Conceptual Review Agenda

Re: 428 Maple St. - Microbrewery

May 19, 2015

Re: 1112 Birch St. - Parking Lot

CHI ZETA

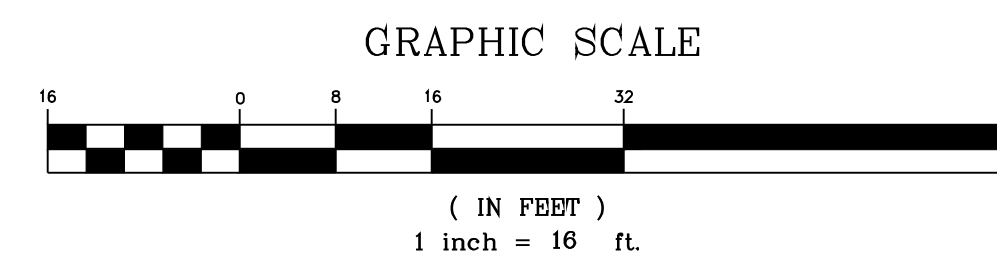
1. LUC 3.2.1(E)(4)(b) Screening. Parking lots with six (6) or more spaces shall be screened from abutting uses and from the street. Screening from residential uses shall consist of a fence or wall six (6) feet in height in combination with plant material and of sufficient opacity to block at least seventy-five (75) percent of light from vehicle headlights.
2. LUC 3.2.2(J) A minimum average of entire landscaped setback area is 5 foot along a lot line. (containing 6 or more parking spaces)
3. Light sources shall be concealed and fully shielded and shall feature sharp cut-off capability so as to minimize up-light, spill-light, glare and unnecessary diffusion on adjacent property.
4. Do you have any handicap parking spaces?

All public sidewalk, driveways and ramps existing or proposed adjacent or within the site need to meet ADA standards, if they currently do not, they will need to be reconstructed so that they do meet current ADA standards as a part of this project. I don't know how wide the existing attached sidewalk. The existing driveway will need to be evaluated to determine if the slopes and width will meet ADA requirements or if they need to be reconstructed so that they do. The proposed driveway will need to be constructed so that the sidewalk crossing meets ADA requirements.

9. Drainage out to the street curb and gutter will need to be through a sidewalk culvert. The drainage cannot drain out the driveway to the curb and gutter.

1. The parking lot shall be laid out to minimize the disturbance of existing trees per Land Use Code section 3.2.1(F). Any significant trees that are removed shall be mitigated per the requirements in section 3.2.1(F)(1) of the Land Use Code. Please contact the City Forester, Tim Buchanan, at tbuchanan@fcgov.com or 970.221.6361 to discuss the trees on the site.

2. The parking lot perimeter and interior landscaping shall meet the requirements contained in sections 3.2.1(E)(4) + (5) of the Land Use Code. You will likely meet the perimeter landscaping requirement by retaining the spruce trees in the northwest corner. The interior landscaping shall comprise 6% of the overall square footage of the lot. Landscaped islands are a good way to achieve this code standard.

4. Please retain the mature tree on the south end of the site in a landscape island with corresponding flare to the access driveway.
5. Please retain the spruce trees in the northwest corner and reconfigure the parking lot to gain a space in the northeast corner.

6. Please show the adjacent mature trees abutting the west property line that are located off-site.
7. The proposed development is subject to a Basic Development Review, please contact the Zoning Department regarding your formal submittal.
